Delegated Report

Householder Planning Application

Planning Application No: 20221231

Description: Replace roof & raise roof height to create a first floor, replace the attached garage, new windows and rooflights, new external cladding and extension to the front elevation

Proposed

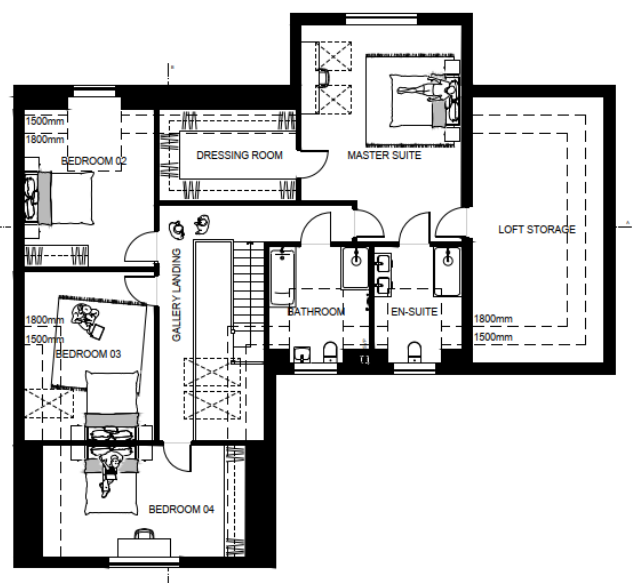
The internal dimensions of the proposed replacement garage would be 5.1m (Length) x 3.7m (Width). The KCC Vehicle Parking Standards (2006), require single garages to have internal dimensions of 5.5m (Length) x 3.6m (Width). The garage proposed therefore does not have sufficient length for appropriate vehicle parking. However, given the minor shortfall, it will still be adequate for parking of one vehicle, with spacing for an additional vehicle on the drive to the front available. There are not details of cycle parking provision and this could not be accommodated within the garage given the internal space. If approved,

Proposed

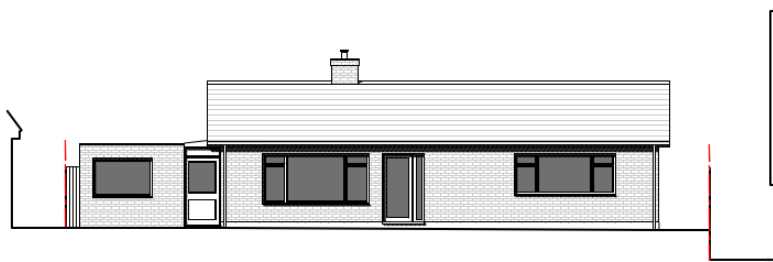
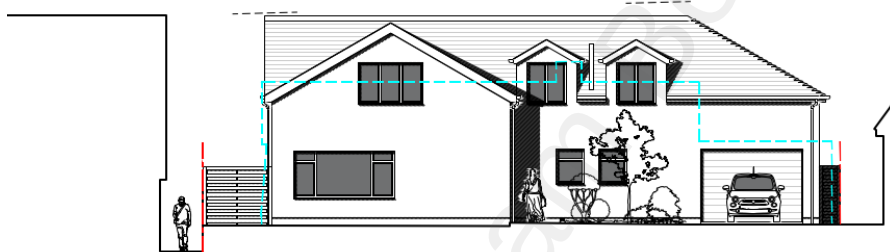
In this particular instance, the proposed development would increase the entire existing footprint to two storey. The result is a wide two storey frontage, which would be prominent and overbearing, without subservient features.

It is noted that the use of dormer windows to the front, somewhat reduce the overall bulk, but would appear incongruent with the existing dwellinghouse given their interruption to the eave line. The arrangement of windows also appear cluttered and clustered together, without taking the opportunity to improve the symmetry of the frontage and therefore also the balance of the dwellinghouse. In particular, the use of larger windows to the first-floor elevation than the ground floor creates a dominant appearance to the higher levels.

The front gable projection is of significant width and prominent which at existing ground floor, is not overtly bulky and harmful but at first floor becomes increasingly so. The increased height over the garage has attempted to reduce bulk and impact by utilising a hipped roof, which again removes opportunity for symmetry and is at odds with the gable roof at the opposite end. Given that this space above the garage is reserved for storage, the increase is an unnecessary addition which creates substantial bulk along the entire width of the dwellinghouse.

The proposed materials externally would be brick and render elevations, dark grey upvc windows and grey slate tiles. The extent of the render/brickwork is unclear and given the rural nature of the area, slate roof tiles would not be appropriate in such a setting where concrete roof tiles are predominant.
